SUBJECT: ISSUANCE OF AMENDMENT NO. 52 TO FACILITY OPERATING LICENSE NPF-35
AND AMENDMENT NO. 45 TO FACILITY OPERATING LICENSE NPF-52 - CATAWBA
NUCLEAR STATION, UNITS 1 AND 2 (TACS 66790/66791)

AMENDMENT NO. 52 TO FACILITY OPERATING LICENSE NPF-35 - Catawba Nuclear Station, Unit 1
AMENDMENT NO. 45 TO FACILITY OPERATING LICENSE NPF-52 - Catawba Nuclear Station, Unit 2

3/4.7.8 SNUBBERS

SAFETY EVALUATION BY THE OFFICE OF NUCLEAR REACTOR REGULATION
RELATED TO AMENDMENT NO. 52 TO FACILITY OPERATING LICENSE NPF-35
AND AMENDMENT NO. 45 TO FACILITY OPERATING LICENSE NPF-52

FIGURE 4.7-1
 SAMPLE PLAN 2) FOR SNUBBER FUNCTIONAL TEST

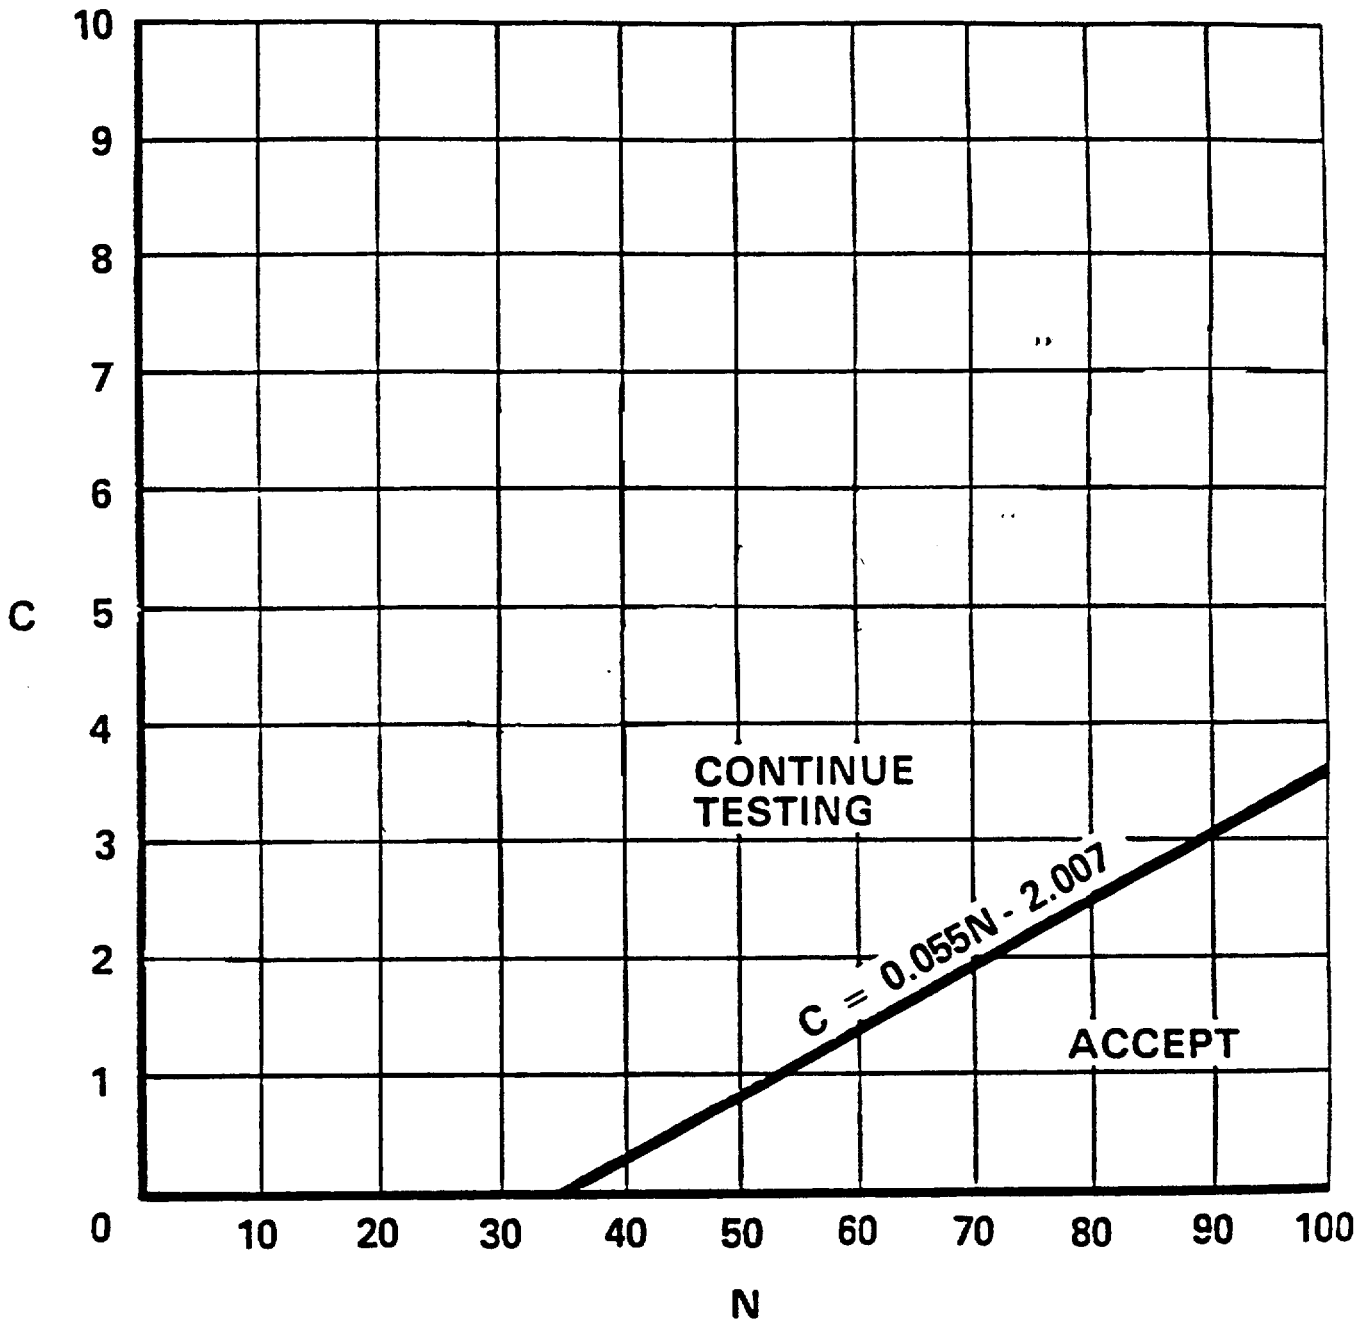
Change 2 would revise the acceptability criteria for snubber testing by the "37" functional test plan in Surveillance Requirement 4.7.8e.2) by deleting the "reject" line from Figure 4.7-1, which could unnecessarily require the functional testing of all 1600 snubbers. The change would also delete references to the "reject" region in the text of T.S. 4.7.8.e.2). A similar revision was approved in TS amendments 46 and 27, issued September 30, 1985, for McGuire Nuclear Station, Units 1 and 2, respectively.

In the "37" functional test plan, the number of test failures (C) is plotted in Figure 4.7-1 against the number of snubbers tested (N). The "accept" line in Figure 4.7-1 represents the equation $C = 0.055N - 2.007$ and is the criterion for ensuring, at the 95% confidence level, that a "bad" population of snubbers (defined as more than 10% failing the inspection test) would not be accepted. If any snubber(s) in the first sample of 37 snubbers failed inspection, sampling and testing would continue until the number of failures plotted against the number tested fell below the "accept" line.

The "reject" line in Figure 4.7-1 represents the equation $C = 0.055N + 2.007$ and is the criterion for ensuring, at the 95% confidence level, that a "good" population of snubbers (defined as less than 2.5% failing the inspection test) would not be rejected. By this criterion, for example, if more than 4 of the first 37 snubbers tested failed the test, then the total snubber population would be rejected and all 1600 snubbers would have to be inspected. Although the probability for failing the "reject" line criterion is very small for a population meeting the "accept" line criterion, the cost of failure would be high economically and may possibly result in occupational radiation exposure.

The staff has reviewed the effect of deleting the "reject" line from Figure 4.7-1 and determined that the deletion would have only minimal safety implications. The confidence level that a "bad" snubber population will not be accepted only changes from 95% to 94.74%. The proposed deletion is therefore acceptable.
